CONSTRUCTION OF 45 APARTMENT UNITS (42 STUDIO UNITS AND 3 ONE-BEDROOM APARTMENTS WITH 5 VERY LOW INCOME UNITS), 3 STORY OVER BASEMENT WITH 2 LEVELS OF SUBTERRANEAN GARAGE.

45 APARMENTS WITH 5 VERY _OW_INCOME HOUSING 3077 CAHUENGA BLVD. LOS ANGELES. CA 90068

MULHOLLAND SCENIC PARKWAY SPECIFIC PLAN DESIGN REVIEW BOARD Alan Kishbaugh, Chair Jack Dawson, Vice-Chair Ben Di Benedetto Gene H. Klow Michael Kaufman Joshua Link Shahab Ghods January 19, 2017 Demolition of existing 5,556 square-foot commercial structure; and the construction of a new, 38,161 square-foot, threestory, residential apartment with a subterranean 55-car, 21,754 square-foot parking garage. This would result in a total structure of 59,915 square feet with a maximum height of approximately 45 feet. The project includes 186 square feet of covered porch/patio/breezeway/balcony area, 5,737 square feet of hardscape, and associated community amenities. The project is located in the MSP Outer Corridor and on an approximately 24,614 square-foot lot. The project is upslope of the North Cahuenga Boulevard right-of-way and is downslope of Mulholland Drive. The applicant has stated that the project is not visible from Mulhollan

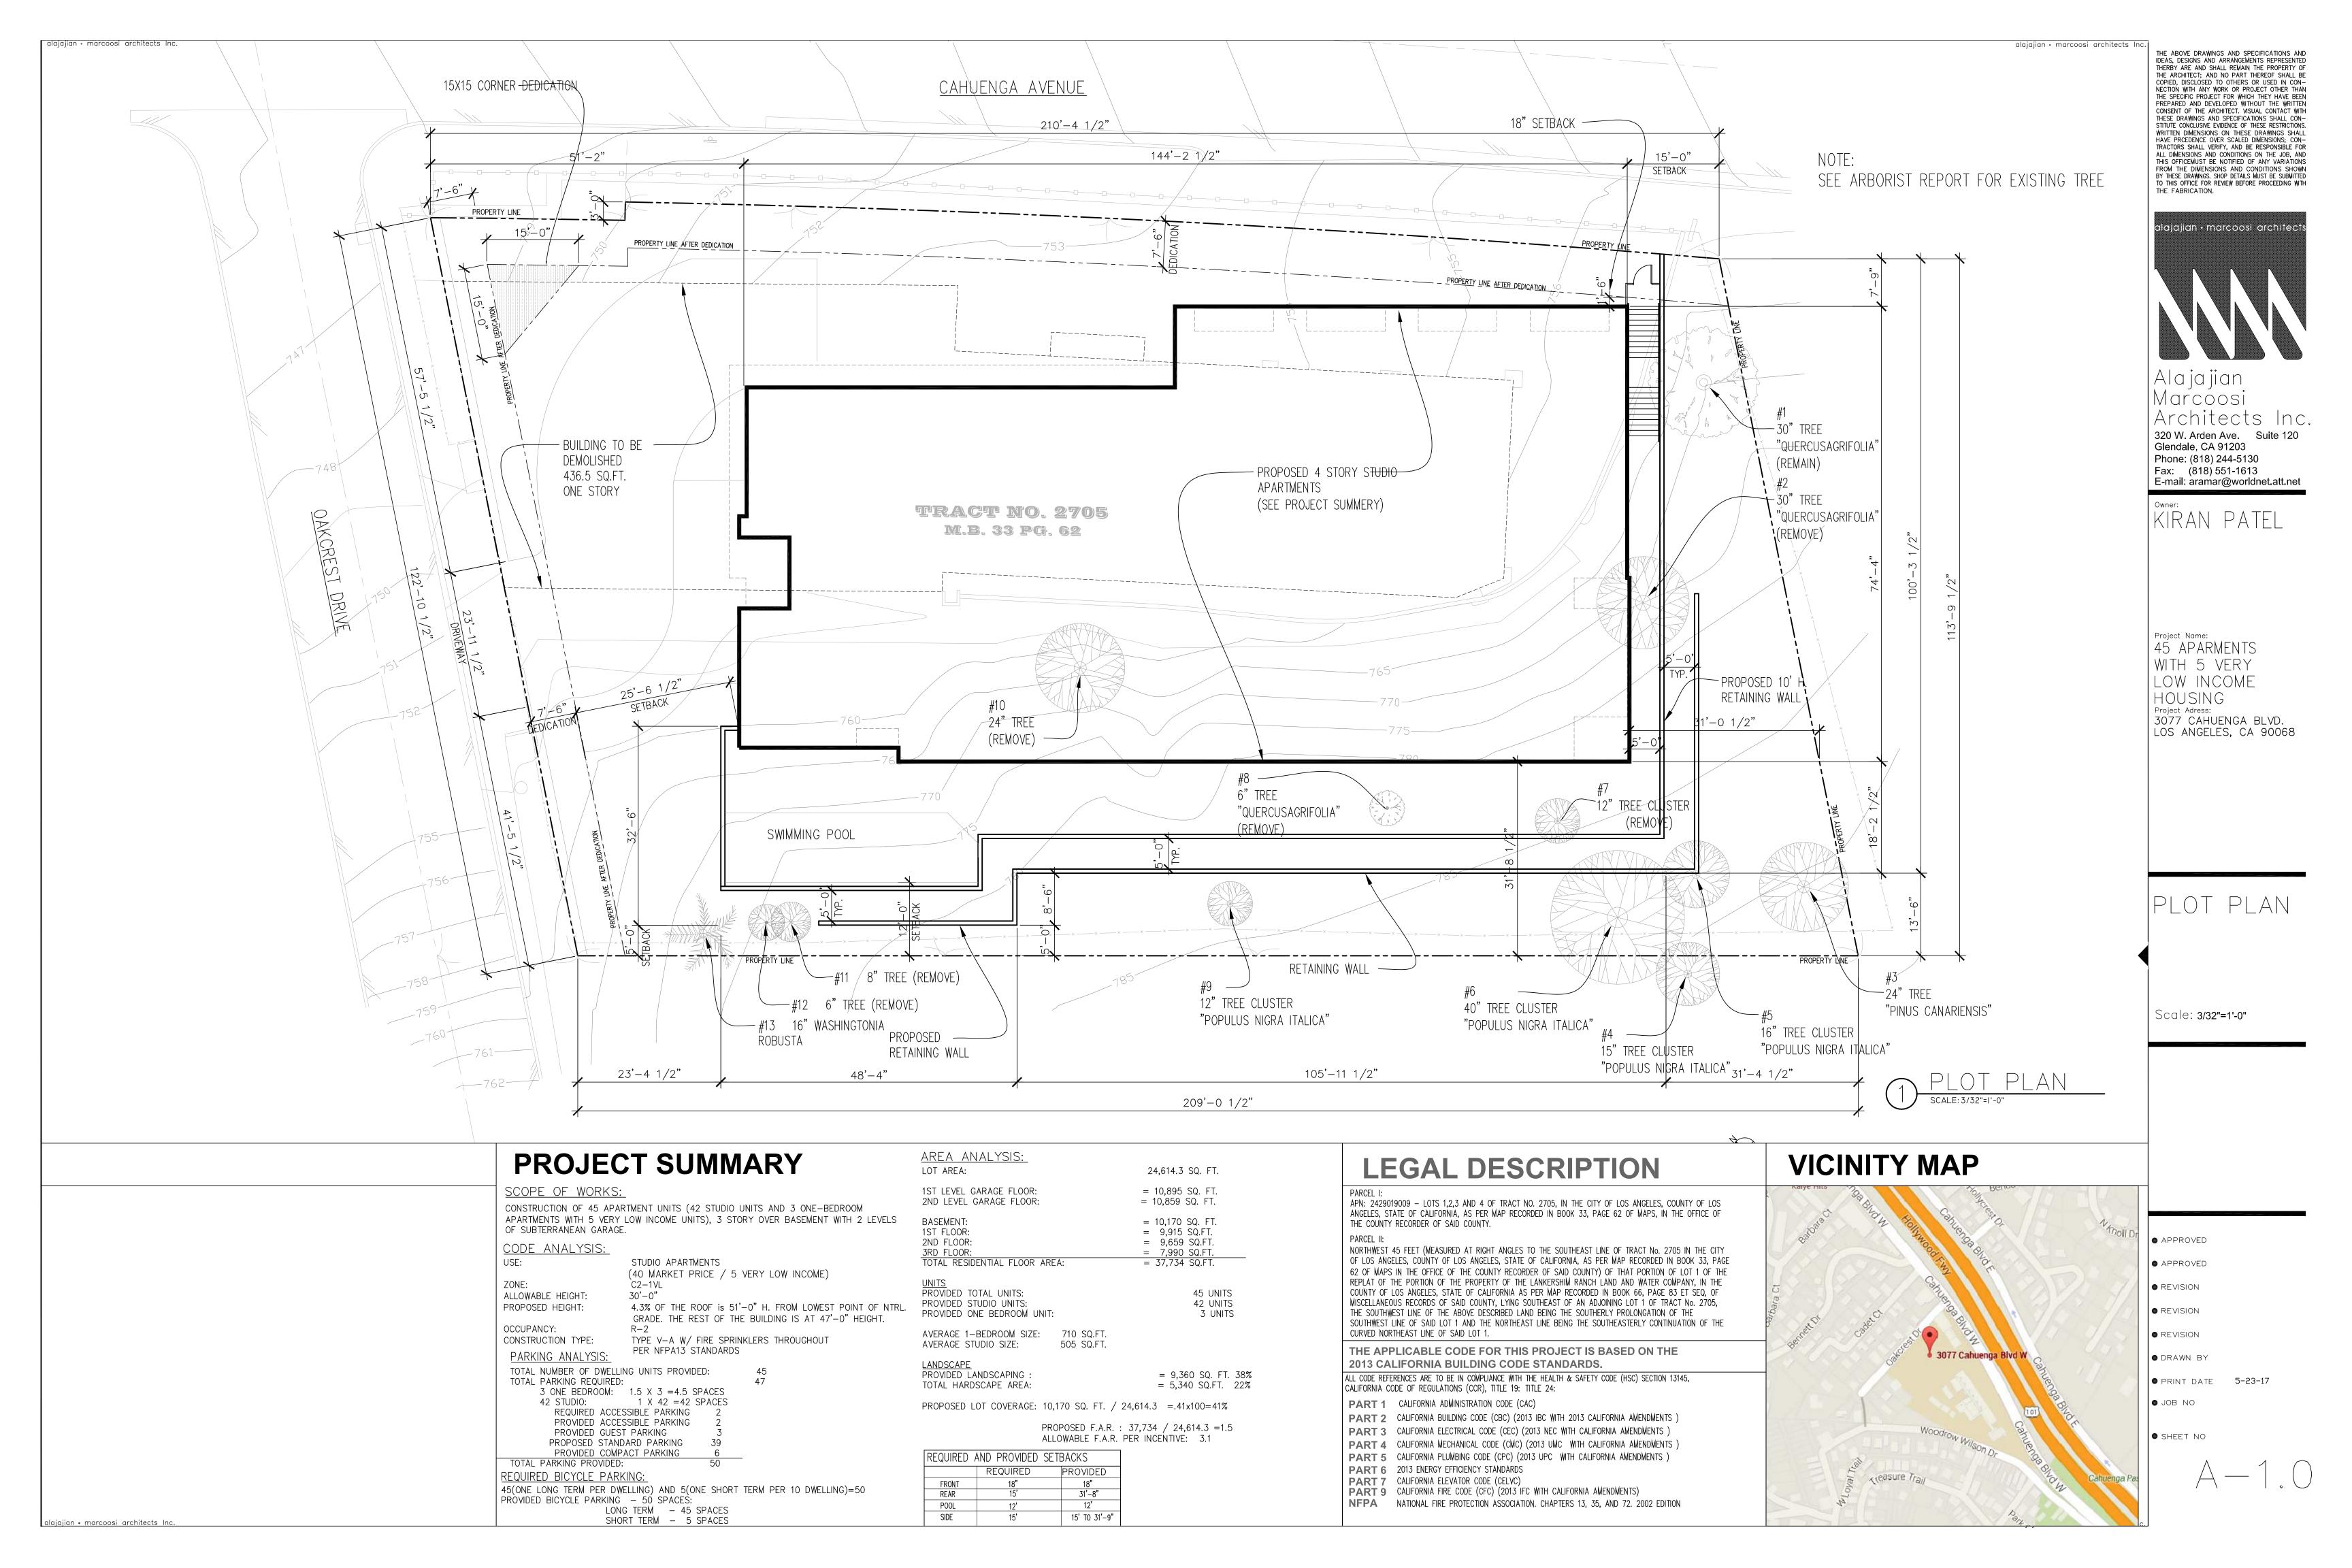
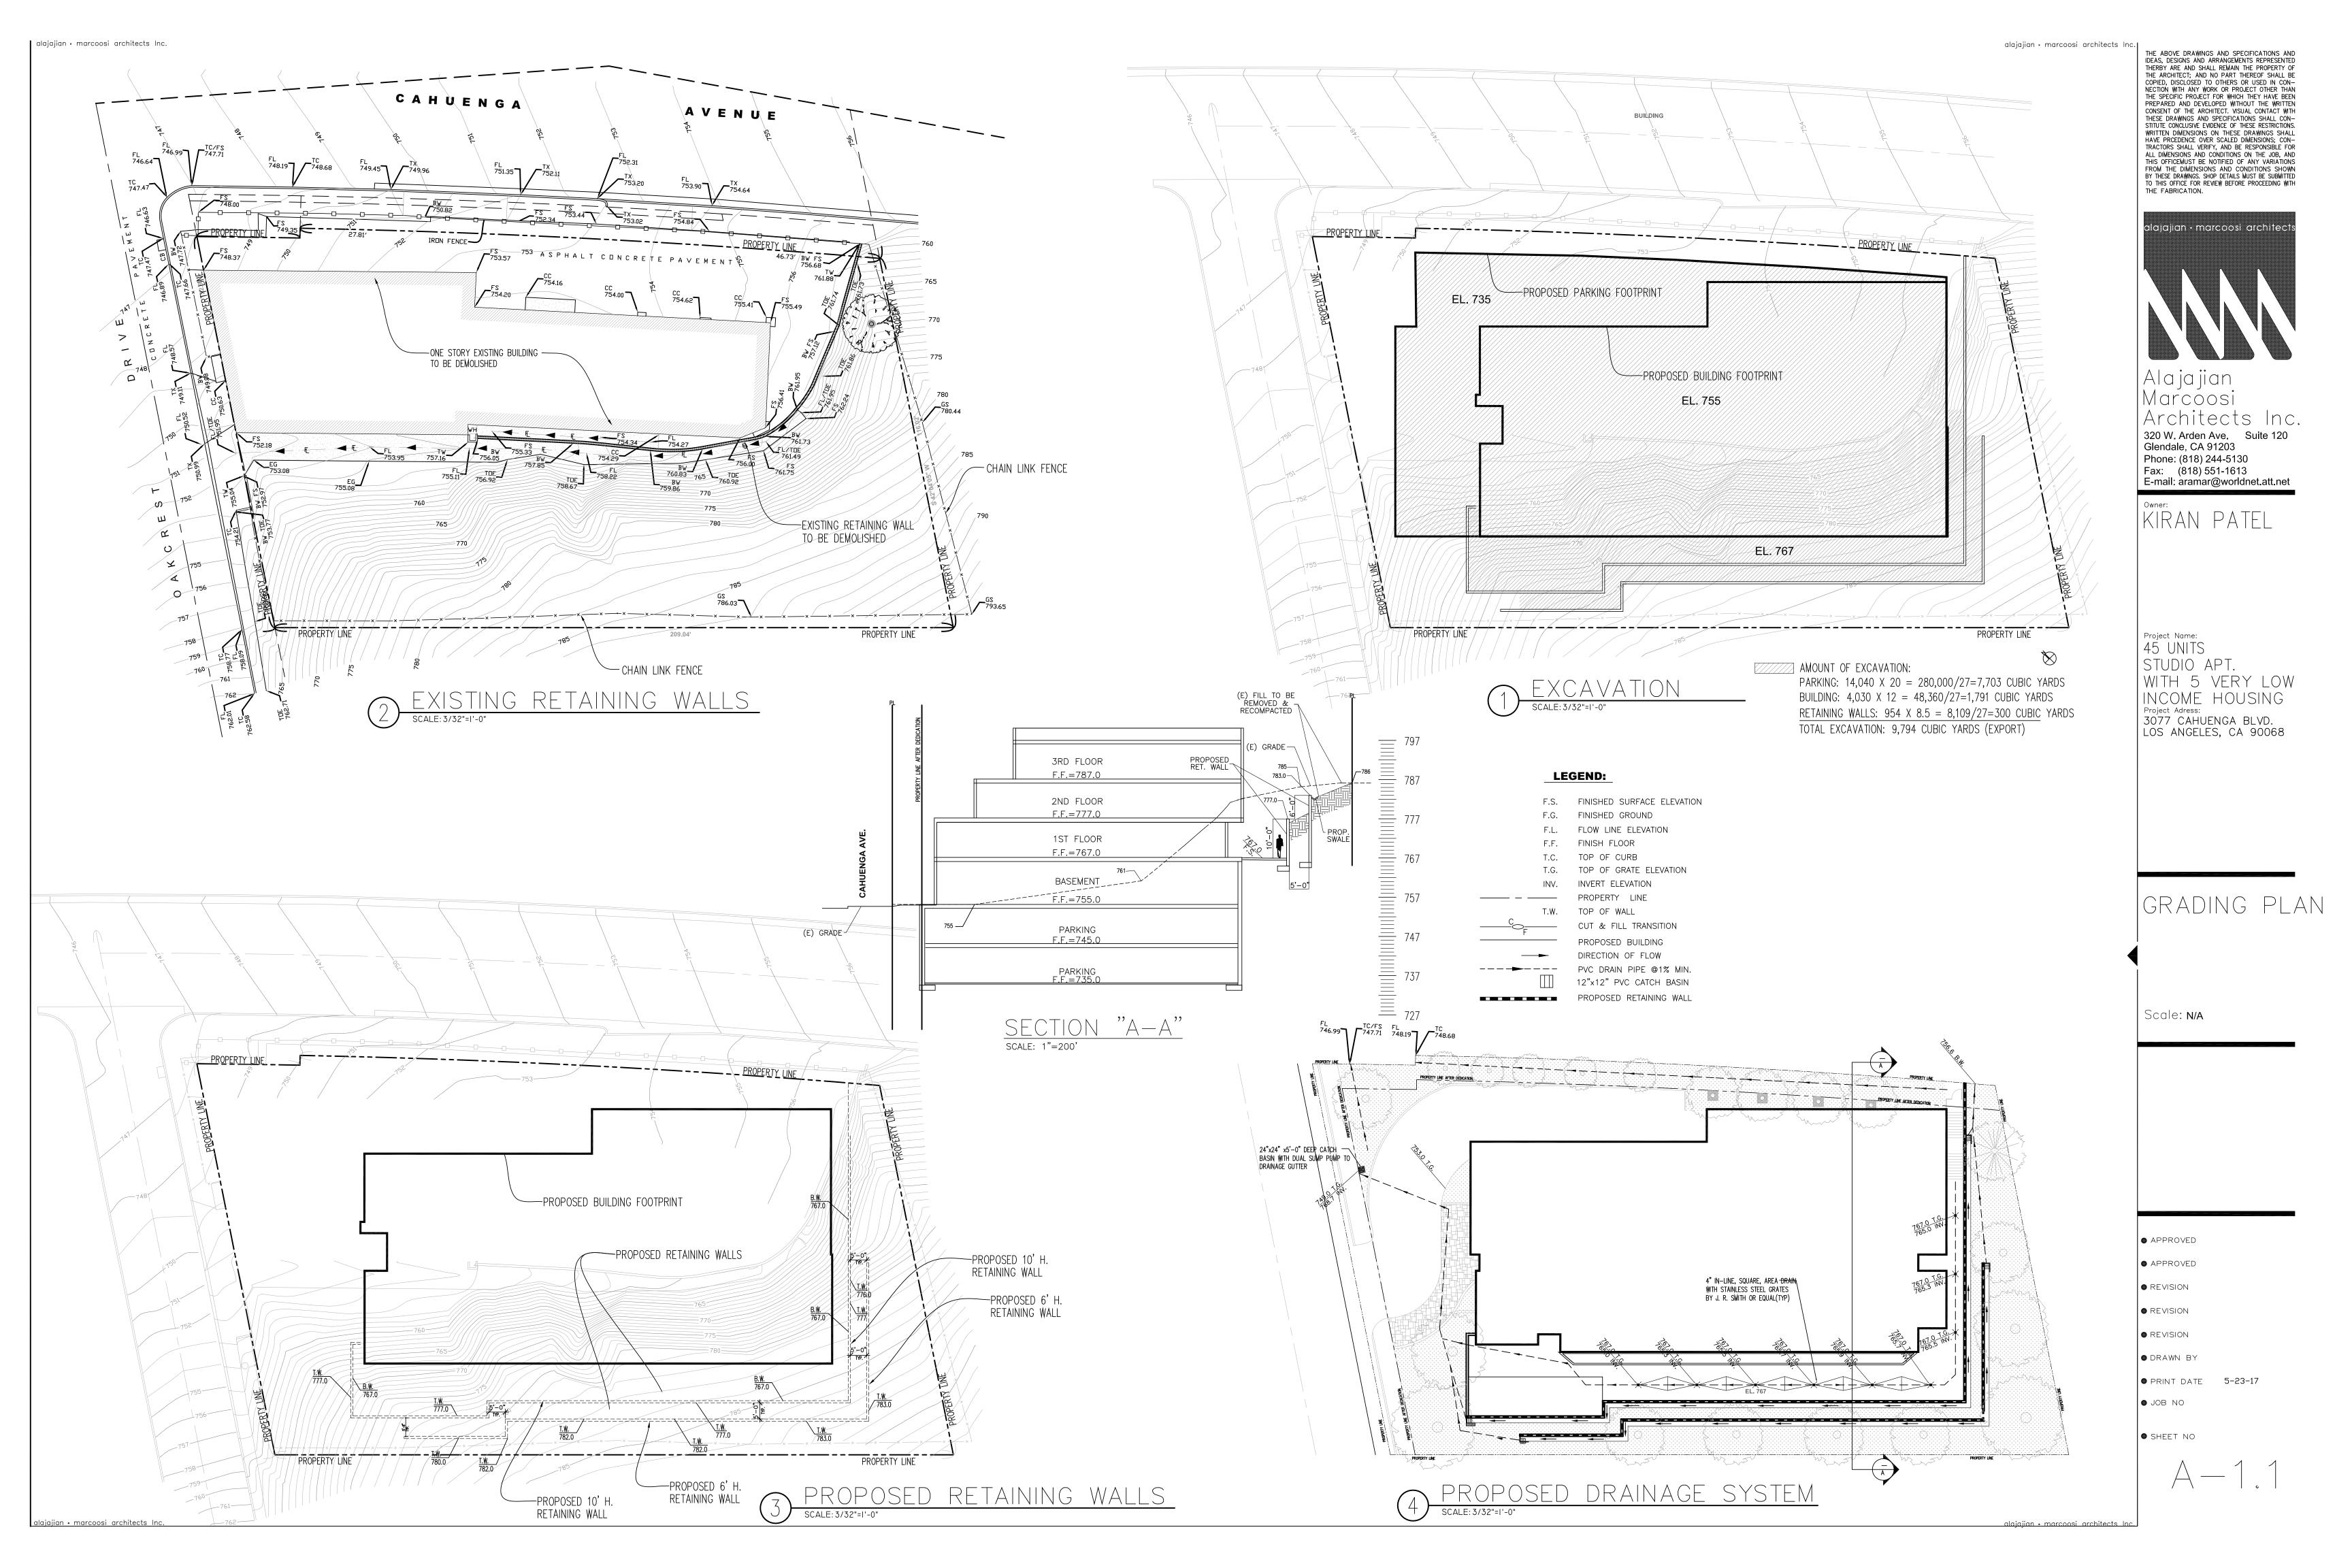
Q: #1 PER GUIDELINE 57, GUIDELINE 60, AND GUIDELINE 73, REPLACE PROPOSED CRAPE MYRTLE, HOPESEED BUSH. TEXAS PRIVET. NEW ZEALAND FLAX. AND KANGAROO PAW WITH SPECIES FROM PREFERRED PLANT LIST.

A: LANDSCAPE PLANS ARE MODIFIED TO ADDRESS THE COMMENT ABOVE. Q: #2 PER GUIDELINE 73, REPLACE PROPOSED RAINBIRD 1812 SERIES NOZZLES WITH HONTER MP ROTATOR OR EQUIVALENT ROTATING, MULTI STREAM NOZZLES.

Q: #3 VERIFY LAMC REQUIREMENTS RELATED TO ADA PAVING, ROOF ACCESS, NUMBER OF FLOORS, SETBACKS, OPEN SPACE, RETAINING WALL DIMENSIONS, NEAR YARD RETAINING WALL DIMENSIONS AND INDICATE THESE MEASUREMENTS OR CALCULATIONS IN THE APPLICATION.

Q: #6 IF POSSIBLE, REDUCE THE RETAINING HEIGHT TO A MAXIMUM OF 16 FEET IN HEIGHT. A: SEE SHEET A-4.1 FIST WALL HEIGHT IS 10' AND 2ND WALL HEIGHT IS 6'

Q: #7 ENSURE THE PROJECT DESIGN BALCONIES THE RESIDENTIAL NATURE OF THE USE WITH THE MIXED USE NATURE OF THE

A: SEE SHEET A-0.1, A-1.2, A-4.1 (PLANS ARE REVISED ACCORDINGLY)

A: SEE SHEET A-3.1 EXTERIOR FINISH MATERIALS

A: SEE PAGE A-0.1 OPEN SPACE CALCULATION

FROM THE FLAT PORTION, MEASURED VERTICALLY. A: DO TO THE HEIGHT LIMITATION OF SPECIFIC PLAN WE CAN'T BRAKE DOWN THE ROOF INTO DIFFERENT ELEVATIONS.
